APACHE CANYON 18-07 API# 05-071-08887 – TIMBER CREEK
OGCC OPERATOR NUMBER 10672 - DATE: OCTOBER 03, 2019
CORRECTIVE ACTIONS COMPLETED REGARDING COGCC FIR DOCUMENT # 689901231

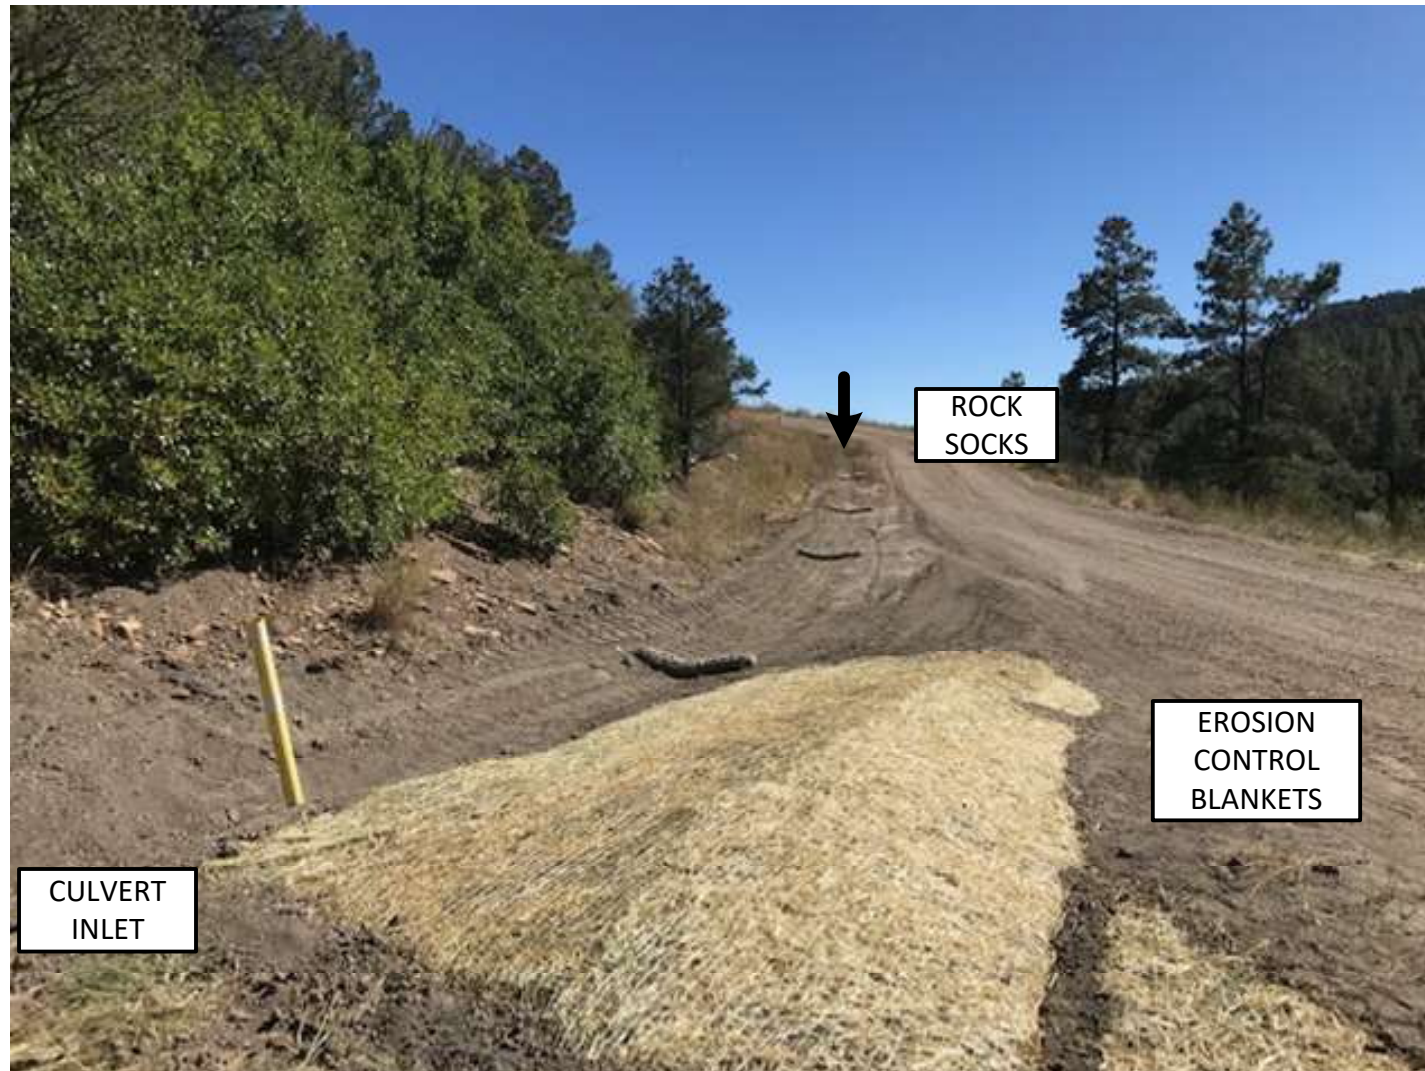
Photo 5: Run off to the culvert along the access road was not diverted to the culvert inlet. The bar ditch was dominated and erosion control blankets were installed where the ground was disturbed for soil stabilization. An approved CPW seed mix was hand broadcast to promote the establishment of vegetation. (4) rock socks were installed in the flow line to filter sediment until vegetation becomes established.
